HYDROLOGY N16/D4 3 PLANS

This drainage plan covers the area being developed by Mueller Aviation at the General Aviation Facility at Albuquerque International Airport.

GRADING AND DRAINAGE PLAN
MUELLER AVIATION

| CONTINENTAL ENGINEERING CO. 811 DALLAS N.E. - ALBUQUERQUE - NEW MEXICO - 87110 ENGINEERS | NO. / DATE / BY / REVISIONS | DESIGNED BY J.G.M. DRAWN BY L.B.D. APPROVED T.T.M. | JOB NO. 40341 DATE 3-84 | GRADING AND DRAINAGE PLAN MUELLER AVIATION | FILE NO. SHEET 1 OF 1 | |

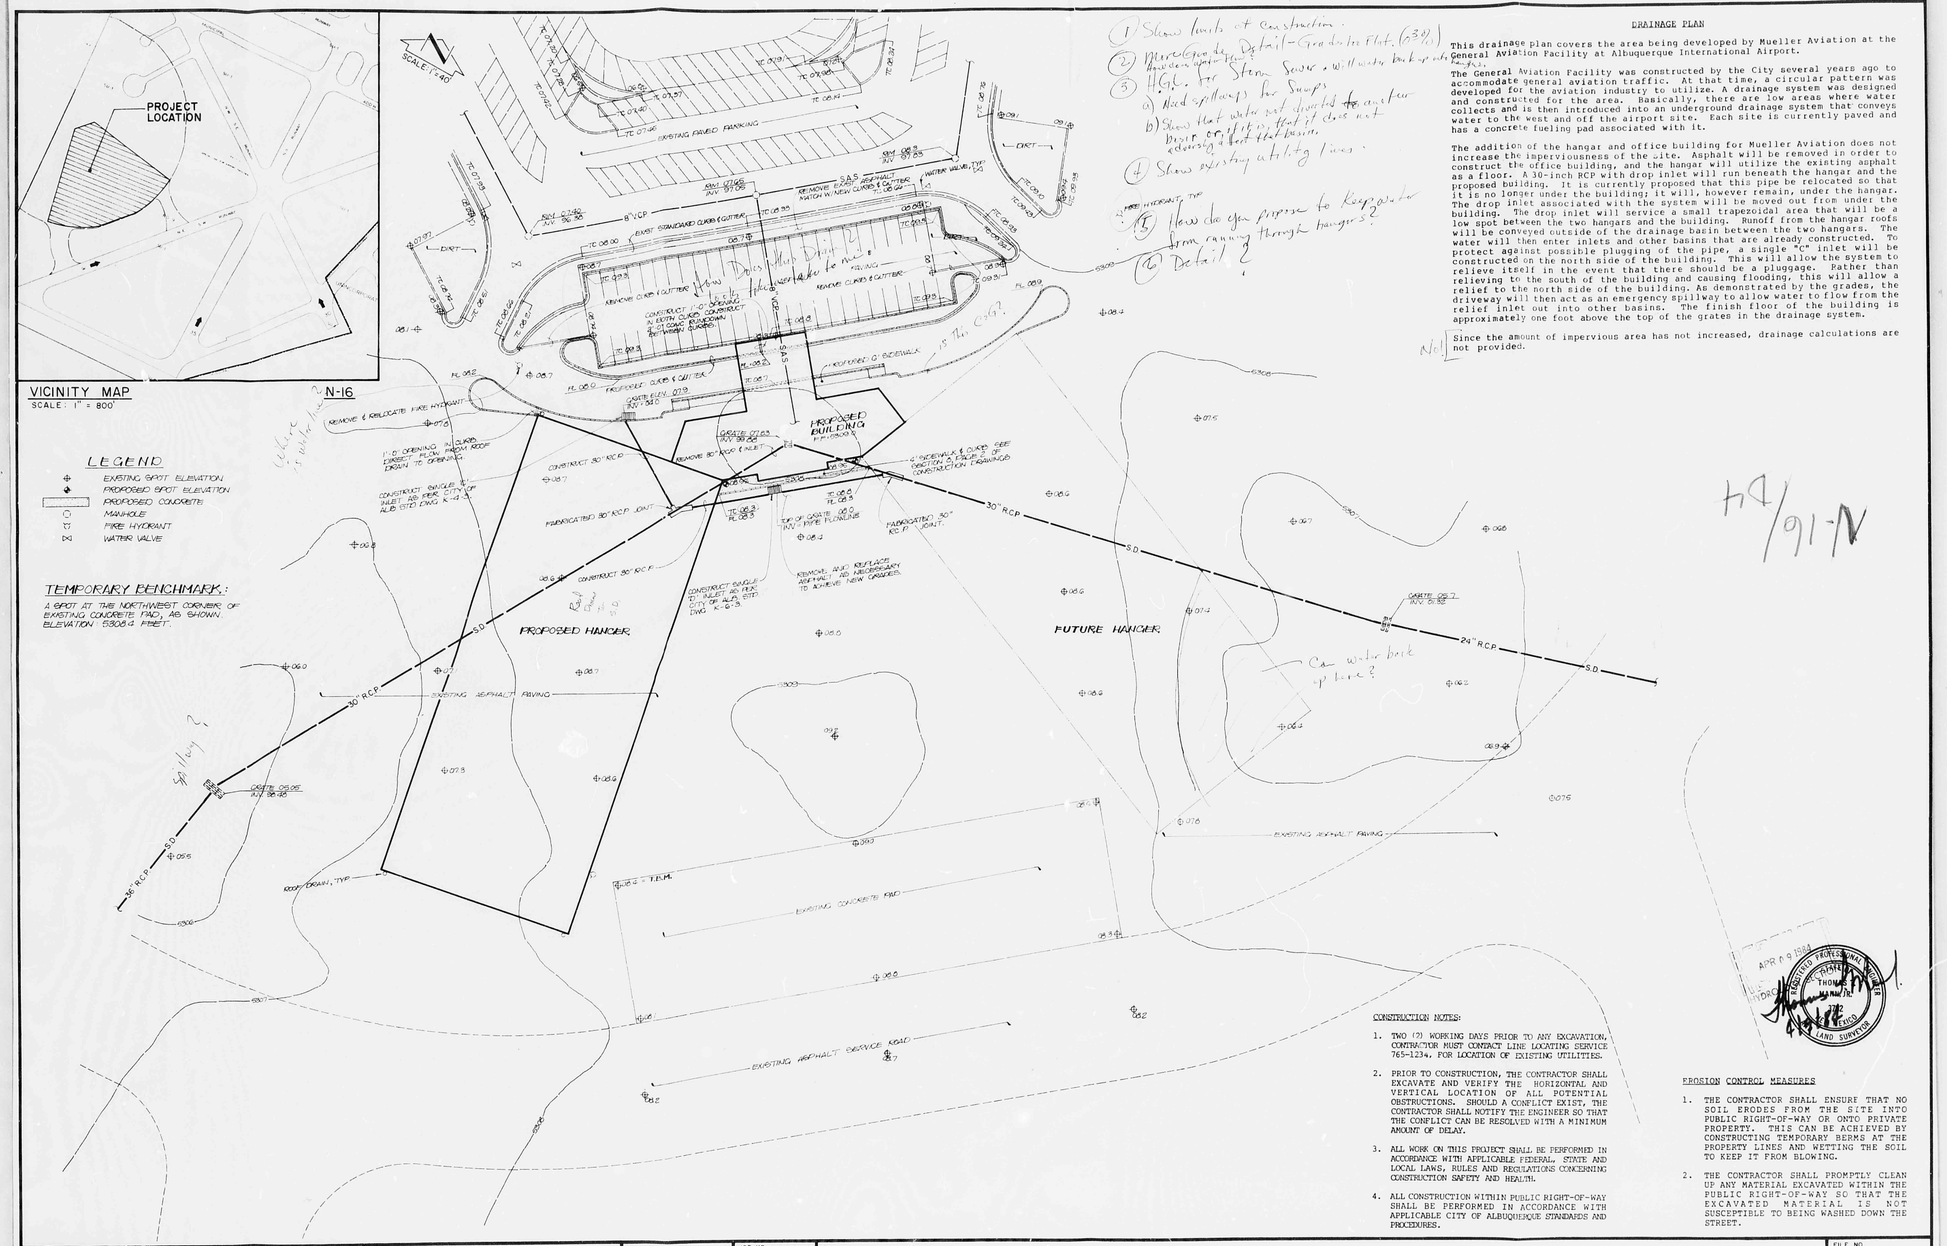
1) Show limits of construction.
2) Move Grade to Drainage Detail - Grade to Flat (0.3%)
3) HGL for Storm Sewer. Will water back up into hangars.
a) Need spillway for Swales
b) Show that water not directed to neighbor. Prior approval in writing that it does not adversely affect that basin.
4) Show existing utility lines.
5) How do you propose to keep water from running through hangers?
6) Detail?

Can water back up here?

Spillway?
